Access Compliance Report

Public Rights-of-Way (Curb Ramps)

Intersection ID: 4480	Main Street: KEMPSFORD_DR	Cross Street: SILVER_GLEN_LN	Location: NW
ADA ID: 931C8BF0C768	Ramp Type: Perp	Initial Pass/Fail: Pass	Overall Compliance: No Severity Score: 20

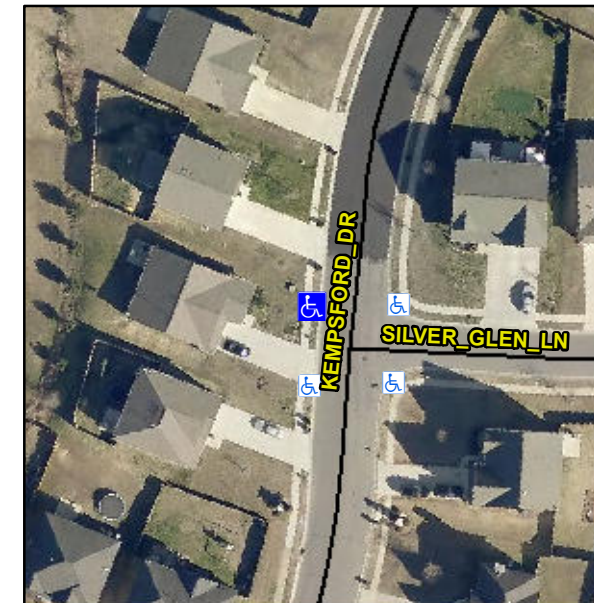
**Not Found, R304.2.1, R305.2,
R302.7.2, R304.5.4**

Compliance	Description	Data	Compliance	Description	Data
N/A	Ramp Length (in)	48.0	Yes	Ramp Slope (%)	7.7
Yes	Ramp Width (in)	48.0	Yes	Ramp XSlope (%)	0.7
N/A	Flare Type LT	Sloped	N/A	Flare Type RT	N/A
N/A	Flare Slope LT (%)	6.2	Yes	Flare Slope RT (%)	6.9
N/A	Flare Traversable LT?	Yes	N/A	Flare Traversable RT?	Yes
No	Landing Length (in)	47.0	Yes	DWS Provided?	Yes
Yes	Landing Width (in)	48.0	Yes	DWS Contrast?	Yes
Yes	Landing Slope (%)	0.8	Yes	DWS Length (in)	24.0
Yes	Landing X Slope (%)	0.3	Yes	DWS Full Width?	Yes
N/A	Landing Curb? (Y/N)	No	No	DWS Offset (in)	5.0
N/A	Shared Landing?	No			
Yes	Gutter Ponding?	No	No	Gutter Slope (%)	7.2
No	Gutter Lip Ht (in)	1.0	Yes	Gutter X Slope (%)	0.6
N/A	Painted X Walk1?	No	N/A	Painted X Walk2?	N/A
	X Walk 1 Direction	To E		X Walk 2 Direction	N/A
N/A	X Walk 1 Width (in)	N/A	N/A	X Walk 2 Width (in)	N/A
	X Walk 1 Slope (%)	3.3		X Walk 2 Slope (%)	N/A
	X Walk 1 X Slope (%)	0.6		X Walk 2 X Slope (%)	N/A

N/A	Ramp inside XWalk1?	N/A	N/A	Ramp inside XWalk2?	N/A
	Road Slope (%)	N/A	N/A	Clear Space?	Yes
	Road X Slope (%)	N/A	N/A	Clear Space to XWalk (in)	N/A
Yes	Any Obstructions?	No	Yes	Storm Grate/Utility Hazard?	No
	Obstruction Type			Storm Grate/Utility Type	
		N/A			N/A
			Yes	Surface Condition? (G/P)	Good

**Remove & Replace Entire Ramp.
Remove & Replace Gutter.**
